Model: Model A-P3		Date: 1-May-02	No.: MG065001
Modified Article: Feed Shaft and Tightener Bracket		Prepared by: E. Fukuyama	
From: Technical Services sec. Service Planning Dept.			
Reason for Modification:	<input type="checkbox"/> Parts catalog correction	<input type="checkbox"/> Vendor change	<input type="checkbox"/> To meet standards ()
	<input type="checkbox"/> To facilitate assembly	<input checked="" type="checkbox"/> To improve reliability	
	<input type="checkbox"/> Part standardization	<input type="checkbox"/> Other

The following changes have been made to reduce noise.

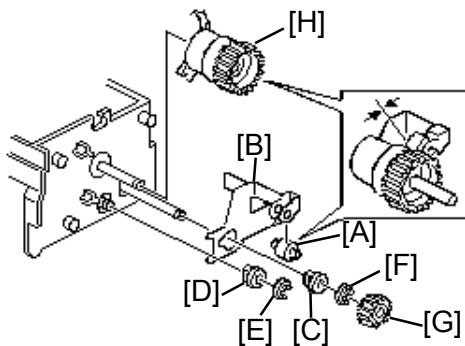
Remove the Tightener Bracket, Retaining Ring, Bushing and Electrical Clutch as shown below.

1. Replace the Feed Shaft with AA140753.

2. Attach the Driven Roller [A] to the Pressure Plate [B], then peel off the outer layers of the double-sided tape (2 places) on the Pressure Plate.
3. Set the Bushing [C] in the hole in the Pressure Plate, then mount the two together onto the Feed Shaft.
Note: Be careful not to let the exposed double-sided tape contact the Side Plate.
4. Set Bushing [D] in the cutout on the side of the Pressure Plate, then push in the Pressure Plate along with the two bushings. After it is set in position, attach e-rings [E] and [F].
5. Press the Pressure Plate firmly against the Side Plate so that the double-sided tape catches and secures the two together.
6. Attach the Gear [G].
7. Attach the Electrical Clutch [H].

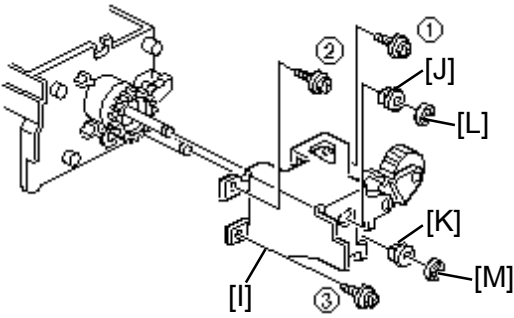
8. Remove the Arm Tightener, Gear and Spring attached to the Tightener Bracket removed in the Prep stage above, then attach them to the new Tightener Bracket [I].
9. Attach the Tightener Bracket [I] and Bushings [J] and [K]. Then, tighten the screws in the order shown.
10. Attach e-rings [L] and [M].

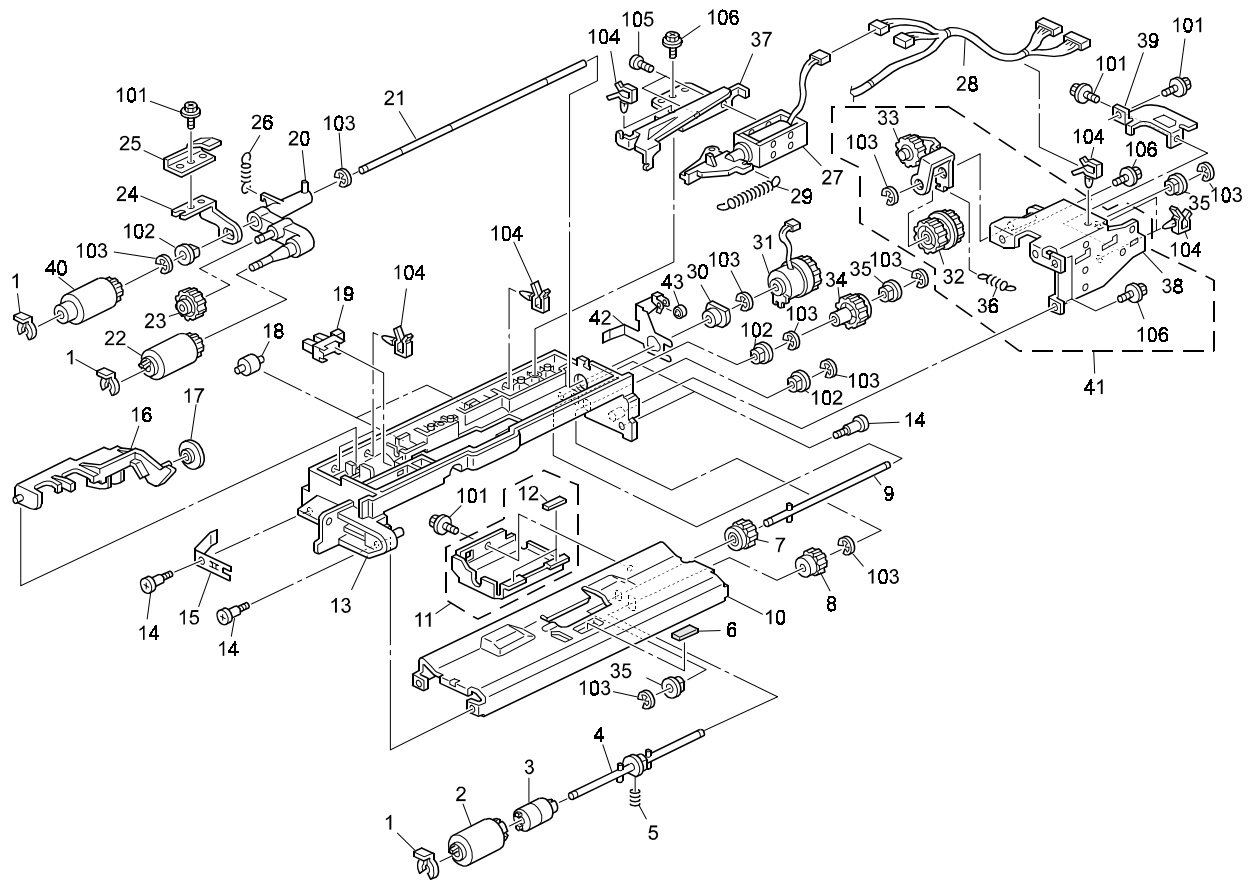
A. Noise generated by vibration of the Electrical Clutch Feed Shaft and Drive Gear:
See the replacement procedure on the next page.

To support the free end of the shaft with a bushing:

1. Lengthened the Feed Shaft from 229mm to 249mm.
2. Added a Bushing and e-ring.
3. Modified the shape of the Tightener Bracket to accommodate the new bushing (hole added).

To hold the clutch firmly in place:

1. Added a Roller to be pressed closely against the clutch.
2. Added a Pressure Plate to attach the Roller.

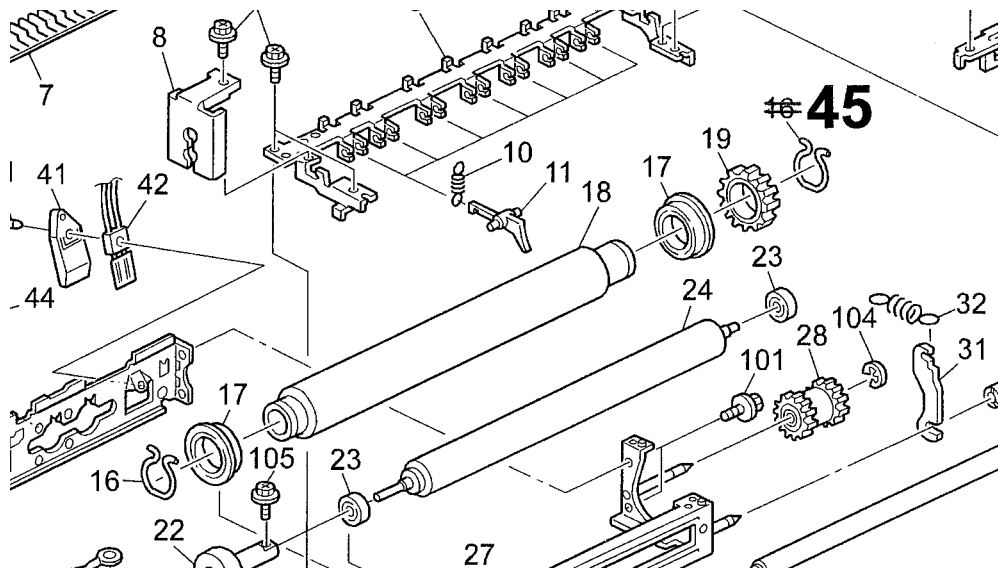
Previously, a pressure-release device was added to the fusing unit maintenance kit to prevent deformation of the Pressure Roller during long periods of storage. However there are cases in the field where this device is not properly removed, and the Hot Roller C-ring detaches when the fusing knob is turned.

The shape of the C-ring ***on the gear side*** has been changed so that it will stay in place even in such cases. Although this only occurs with the maintenance kit, this modification was made because the same C-ring is common to both the kit and the mainframe.

Visual distinction:

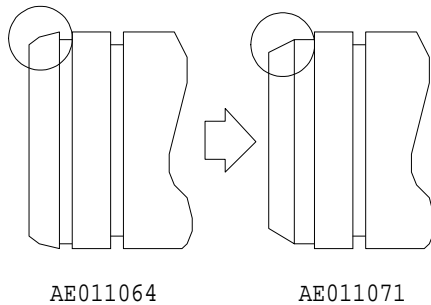
As previously announced in MB #MG065002, the C-ring was modified to ensure that it does not slip off the Hot Roller. However due to variations in roller diameter, it became necessary to separate the thicker rollers out from stock for use on the A-P3. To eliminate this need, and to ensure that all C-rings will stay properly fastened, the outer diameter of the Hot Roller has been increased by 0.2 mm.

The old roller (left) contains a groove on the fusing knob end.

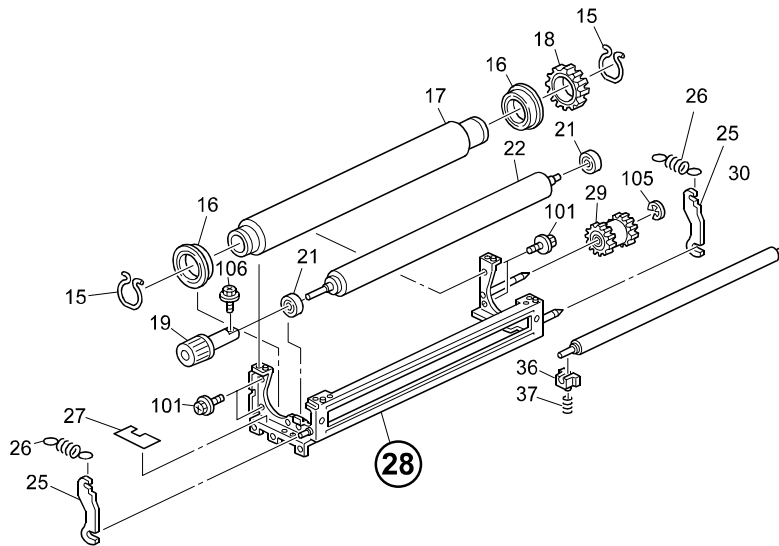
The following has been changed due to a vendor change.

PCU Stopper Spring

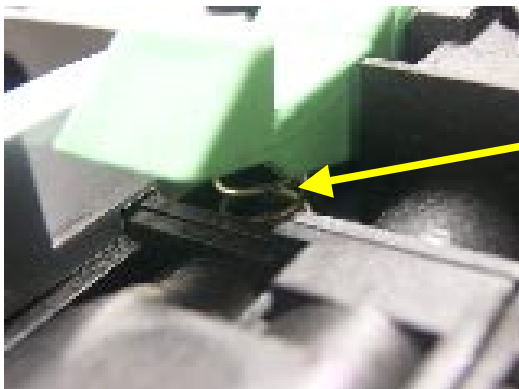
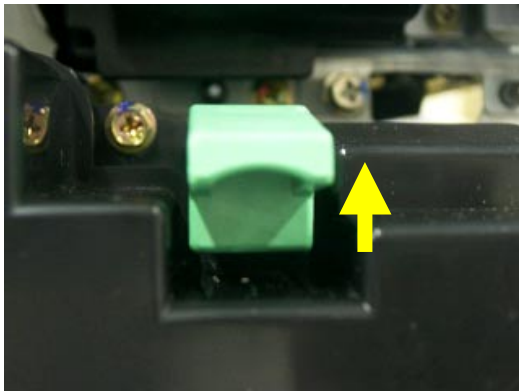
Change: The pressure of the PCU stopper spring was increased (9.8N to 20N).

Reason: To make sure the stopper does not move when drive is supplied to the PCU.

Note: If the stopper moves, the PCU can move out of position a few millimeters. This can cause poor connection of the TD sensor, or incorrect development bias on the development roller.
